Objection submission COM/2019/81 -

Problems and observations with Water quality and the Coomera River originating from the
submitted 'Stormwater Management Plan'

Attachment A2 - Figure 2-2 - Stormwater Management Plan - Key Site Features

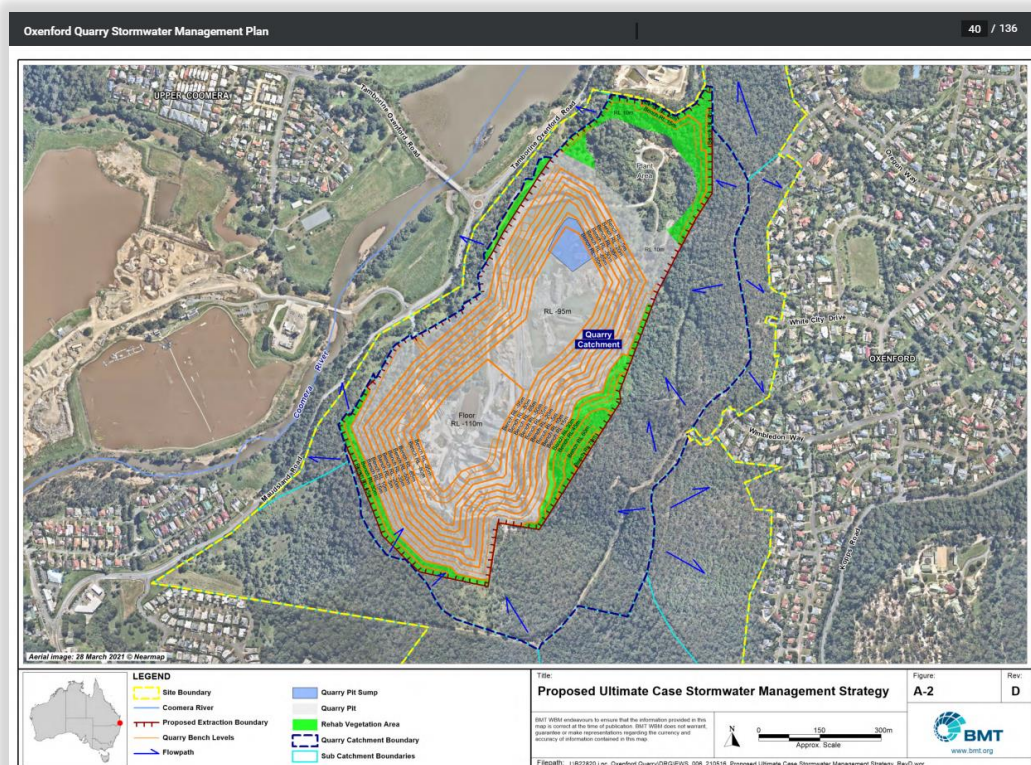
The sump pit used by the quarry, identified as '*Sump C3*', is located in the northern end of the extractive footprint as shown in the '*Key Site Features, Figure 2-2*' map (reproduced in Attachment A2).

It can be seen that any stormwater arriving in the extractive footprint will collect in the '*Sump C3*' and will obviously be contaminated by mixing with the water collected as part of the quarrying process as shown in "*Proposed Ultimate Case Stormwater Management Strategy, Figure A-2*" (reproduced in Attachment A3).

Attachment A3 - Figure A-2 - Proposed Ultimate Case Stormwater Management Strategy

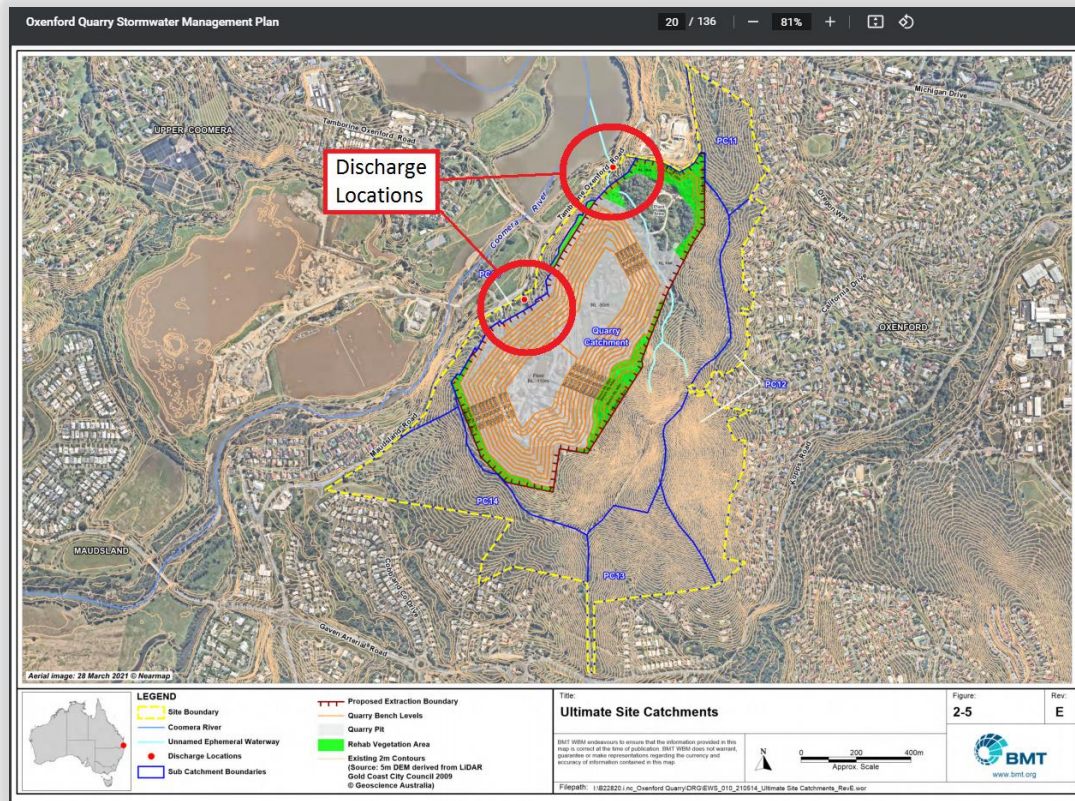
By this stage in the proposed development, it would seem there is no appropriate '*treatment system*' (e.g. sediment basin) as is clearly required by Environmental Authority EA0002207, between the collection sump '*Sump C3*', at the bottom of the extractive footprint and either of the two discharge locations from the site that will ultimately discharge into the Coomera River (as shown in Attachment A4).

There appears to be no appropriate *‘treatment system’* (e.g. sediment basin) available to achieve its water quality objectives required before discharge to the Coomera river, just the quarry sump (as shown in Attachment A3). It would therefore appear the development application does not meet its own requirements and by failing to meet its own requirements is, I believe, harbouring a potential ecological disaster for the Coomera River.

With no settlement pits or containment pits other than '*Sump C3*' in the later stages of quarrying (Attachment A3) if this discharged water is found to be contaminated as I believe is expected (for example by acid sulfates and/or pyrite) how is this going to be decontaminated before release? Where will this colossal volume of water be stored prior to release? It cannot be stored in '*Sump C3*' as this will be forever filling with yet more potentially contaminated groundwater. It is clear, I believe, there is no space for the required sedimentation basin(s).

Figure 4-2 Quarry Pit sump waterbodies and pumping infrastructure

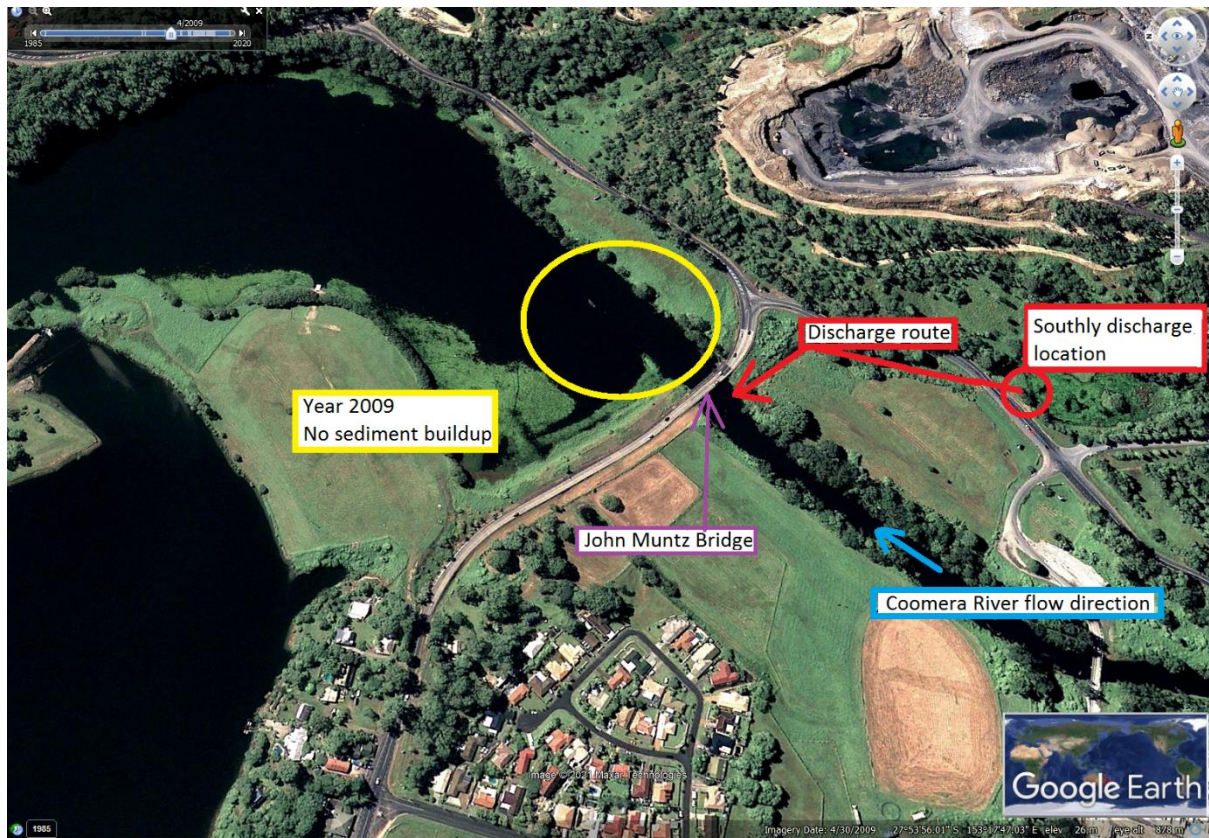
Pumping infrastructure exists within the sump, as seen in Figure 4-2. Prior to pumping to the drainage channel, water is tested to ensure sediment is less than 50 mg/L. It is noted that the drainage channel, pond and swale will also provide some treatment of sediment and nutrients in waters prior to discharge to the Coomera River" (Attachment G1).

It would seem, not only at the later stages of the quarries lifecycle that the required sedimentation basin(s) are not available but the current operation is already operating in a manner that the development application claims is incorrect as highlighted in Section 3.4 of the submitted '*Stormwater Management Plan*' where it states: "*For events up to and including a 24-hour storm event with an ARI of 1 in 5 years (18.1% AEP). The following must be achieved: 1. a sediment basin must be designed, constructed and operated to retain the runoff at the site(s) approved as part of the ERA application*" and "*2. The release of stormwater from these sediment basins must achieve a total suspended concentration of no more than 50mg/L for events up to and including those mentioned above*" (reproduced in Attachment A5).

Attachment H2 - Google Earth image in Year 2017 - Significant sediment build up

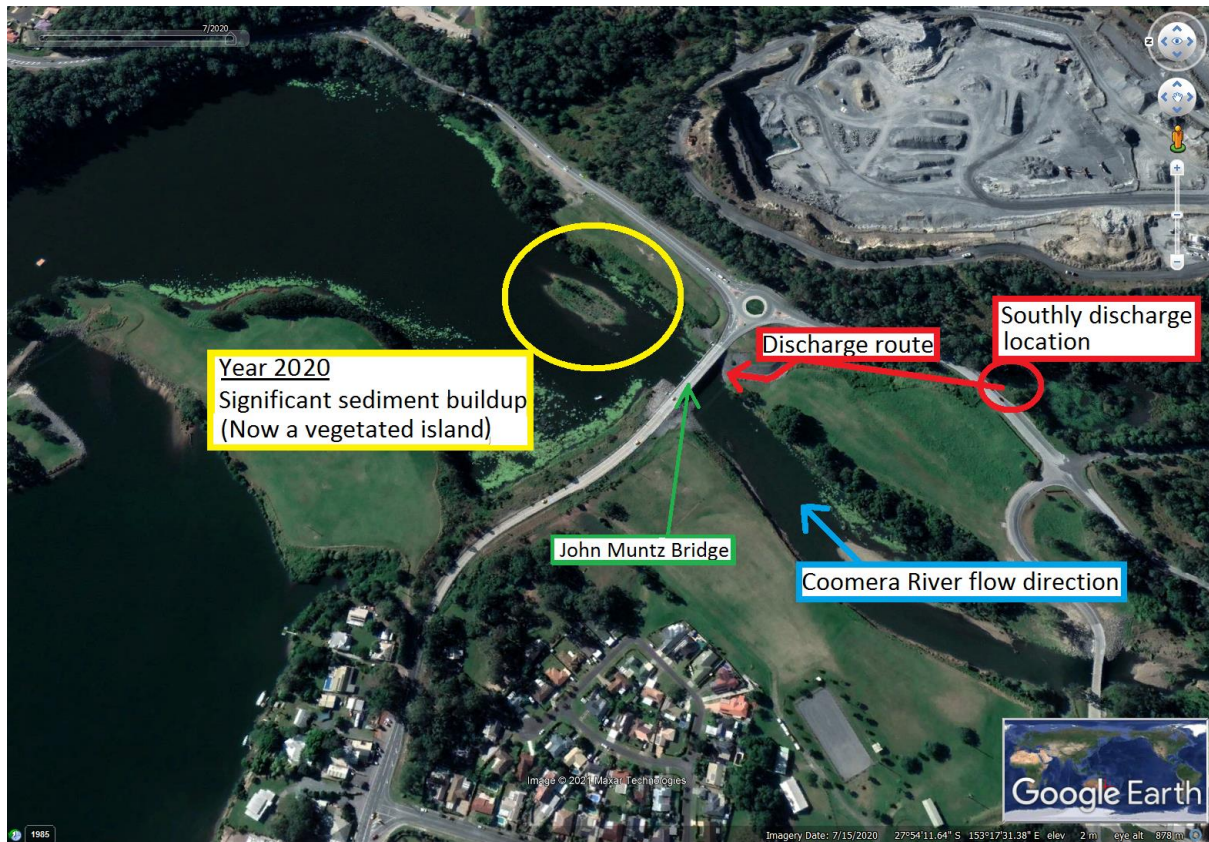
I do hope the City of Gold Coast Planners will not make the same mistake of misjudging the effect that ‘50 mg/L’ of ‘Suspended Solids’ will ultimately have when permitting up to 40 litres of water to be discharged per second, on a 24/7 basis, resulting in, I believe, up to 63 tonnes of sediment per annum allowed to be legally dumped into the freshwater part of the Coomera River. The damage to the local ecosystem will, I believe, be truly immense (if it has not already happening given the lack of monitoring by the DES).

Attachment O3 - Bureau of Meteorology - Groundwater Dependent Ecosystems Atlas (Aquatic)

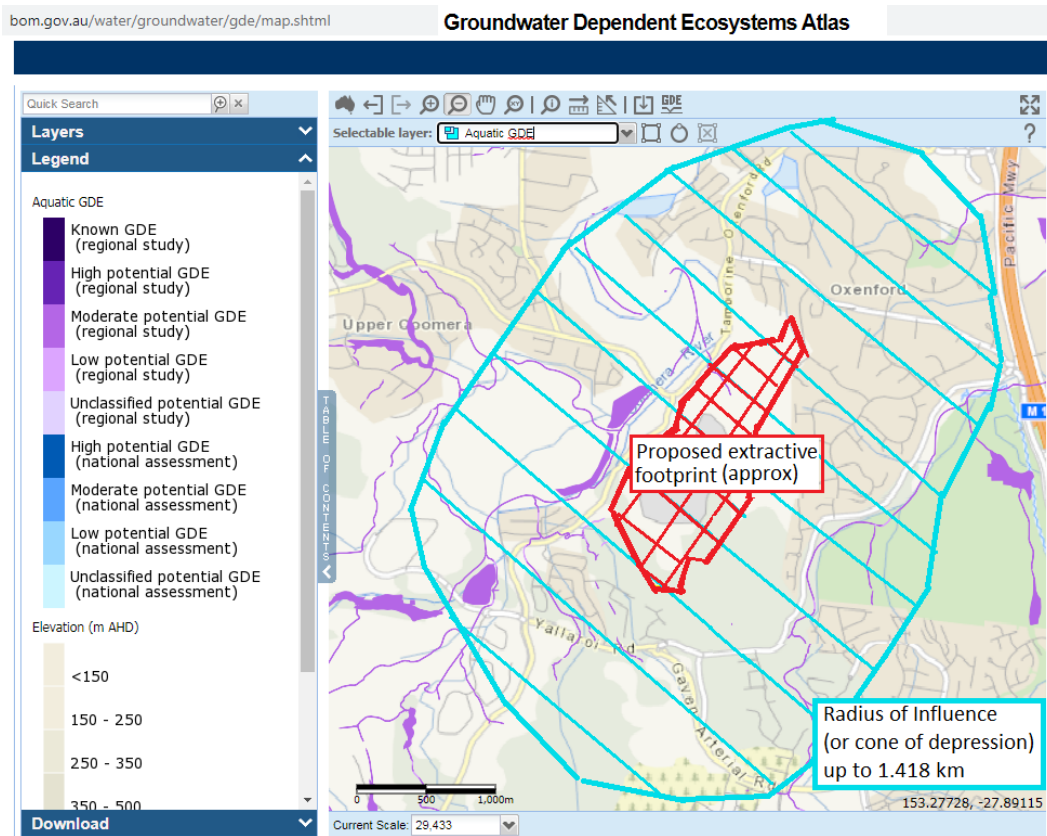
Unfortunately the "*The Bureau of Meteorology (BoM 2017) GDE Atlas*" maps referred to in the development application have not been submitted by the applicant. Therefore, in order to clarify the effects, I have added the proposed extractive footprint and the radius of influence onto these Bureau of Meteorology GDE Atlas map for the '*Aquatic GDE*' as shown in Attachment O3. Similarly, I have done the same for the '*Terrestrial GDE*', reproduced in Attachment O4. From these maps, it is clear to see that the radius of influence will have an extensive effect on a very large area and a highly significant number of Groundwater dependant ecosystems (GDEs) for the next one hundred plus years (or all our foreseeable futures!). It could also affect the many bores in the region (e.g. Movie world, etc.) and may have a significant effect on all homes as the water table is artificially lowered by ongoing quarry operations. The onset of emerging sink holes I believe cannot be ruled out either.

I therefore find the throwaway comment in the development application: "*This radius of influence will only be present during active dewatering of the realigned pit*" thoroughly inadequate and highly misleading (reproduced in attachment O1).
